# Notice of Alteration Form

Dangerous Goods Handling and  
Transportation Act Licence

Re: **NoA for the GFL Facility located at 1090 Kenaston Blvd, Winnipeg, *Dangerous Goods Handling and Transportation Act* Licence No. 334 HW  
Client #4320.10**

**FIGURE 2**  
 SITE LAYOUT AND EMERGENCY EQUIPMENT LOCATIONS  
 12 APRIL 2024  
 GFL KENASTON FACILITY  
 1090 KENASTON BLVD, WINNIPEG, MB  
 DRAWN BY: SAM  
 CHECKED BY: GJW

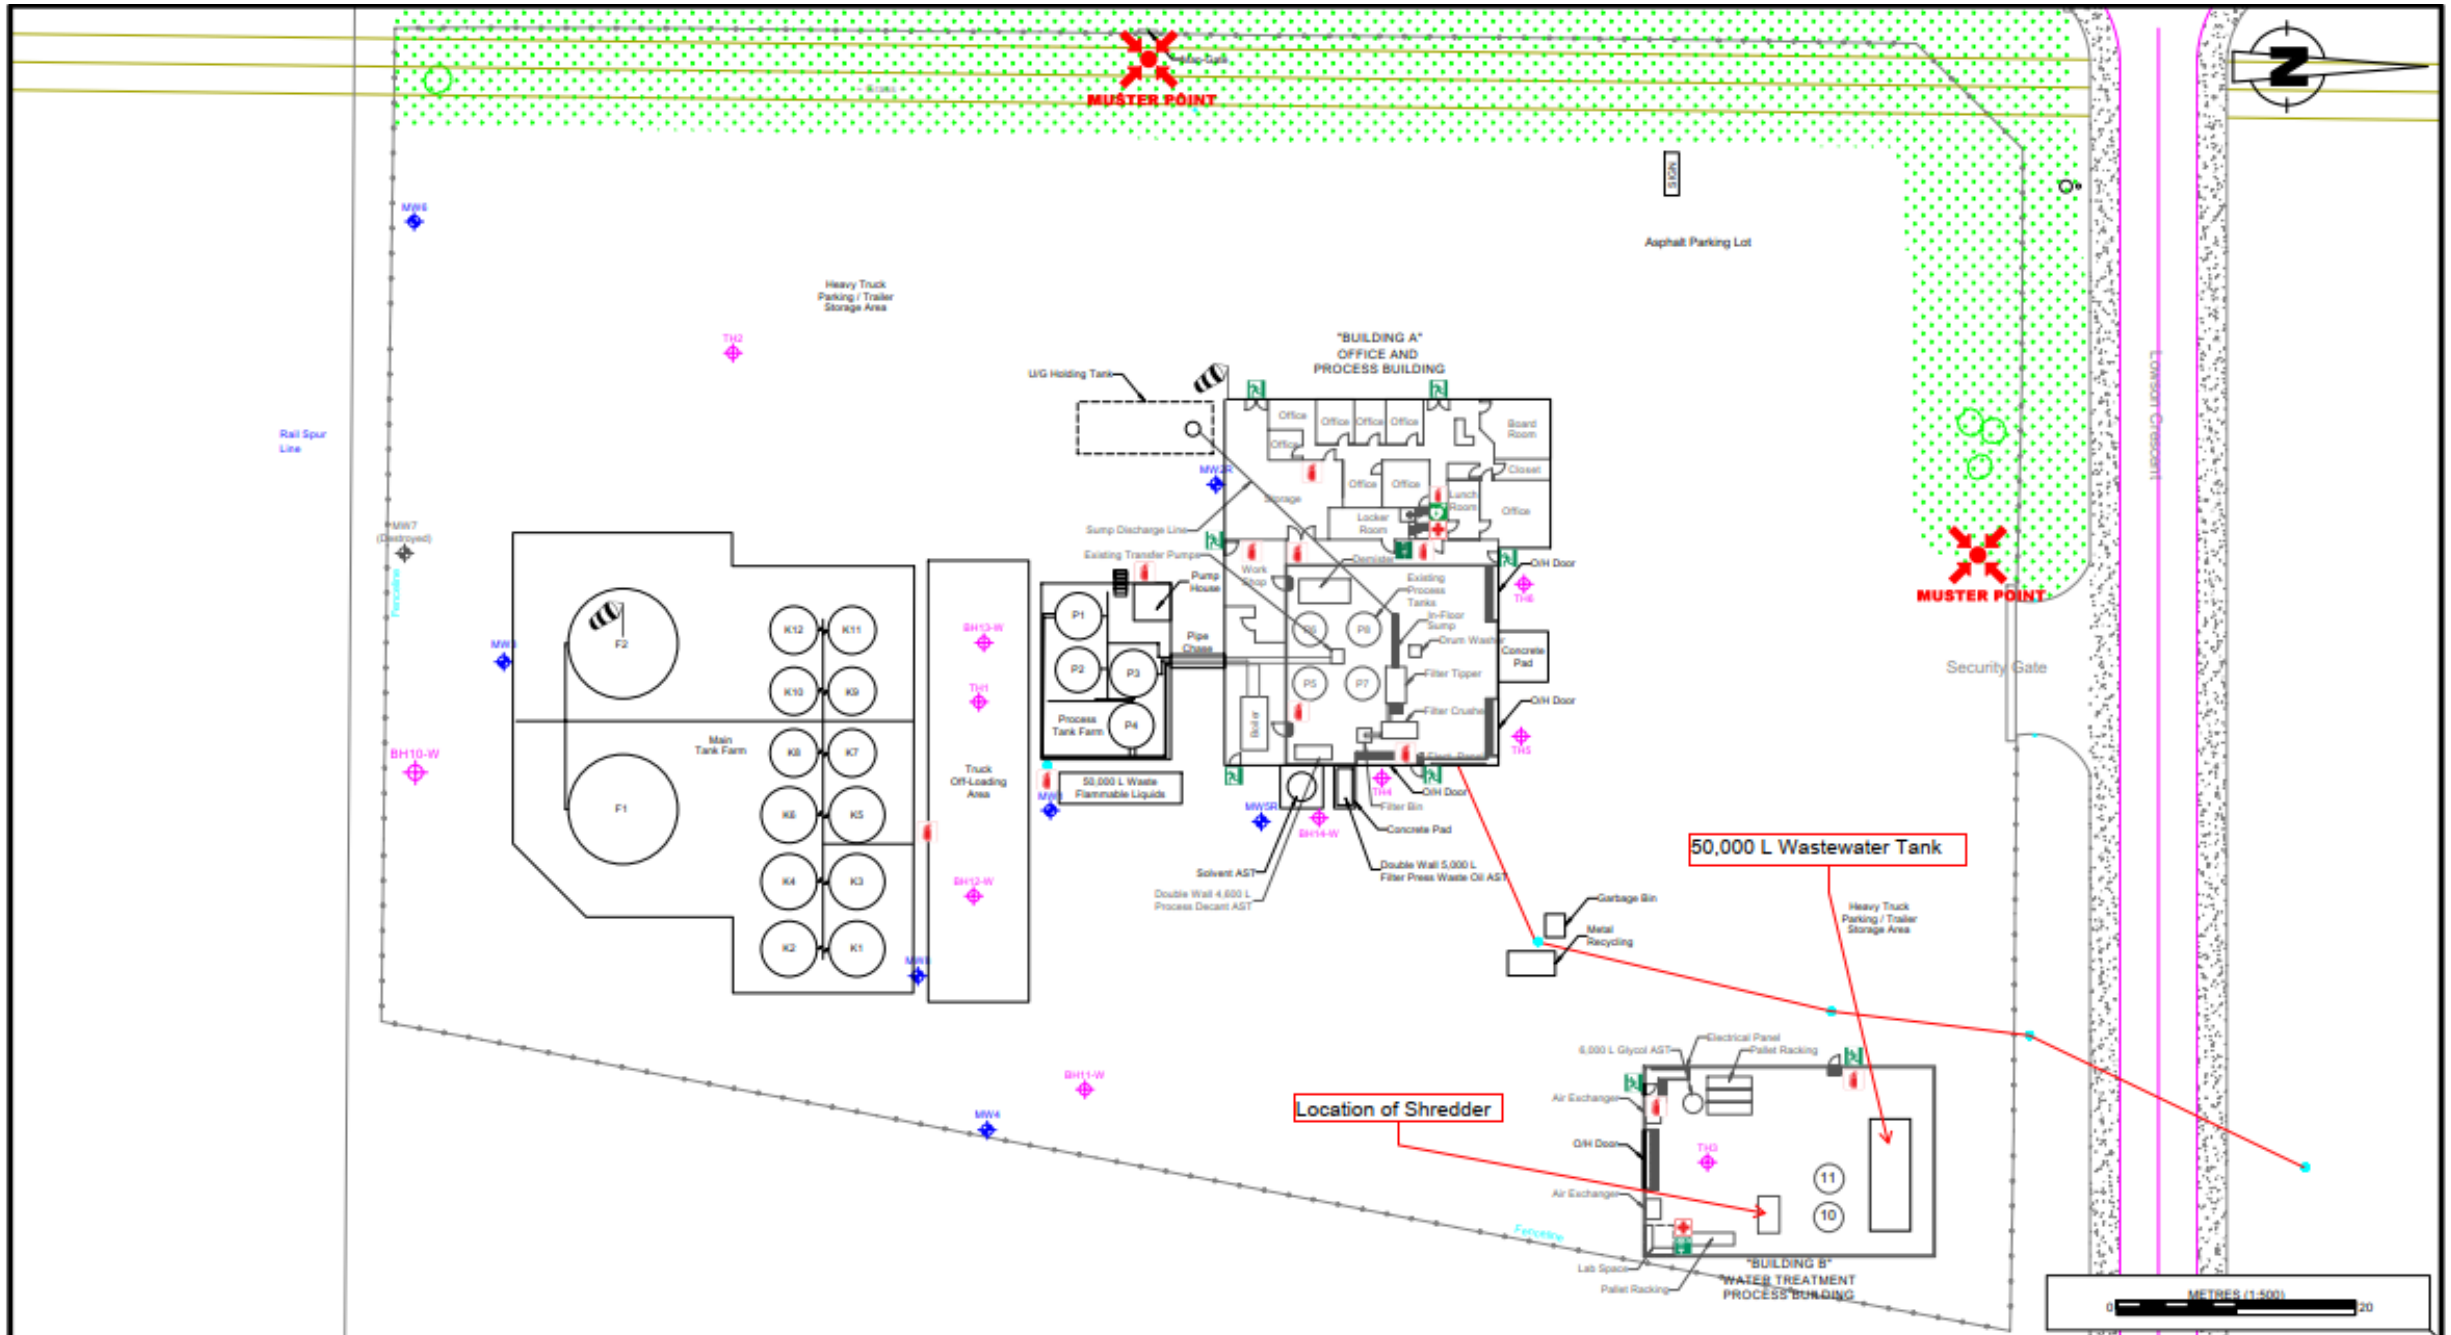
GFL is seeking to alter the Licence with respect to the configuration of the tanks located in Building B. Tanks identified in items a, b, c, d, and e are being removed from Building B in their entirety. Tanks T10 and T11 (item f) will be the only tanks left in this building.

As part of the alteration, the AST that was approved under the February 2024 NoA, will be relocated into Building B. Currently this tank is listed under Clause 60 of the Licence and will need to be moved into Clause 62.

A new schematic outlining the location of the tanks at the Facility is attached.
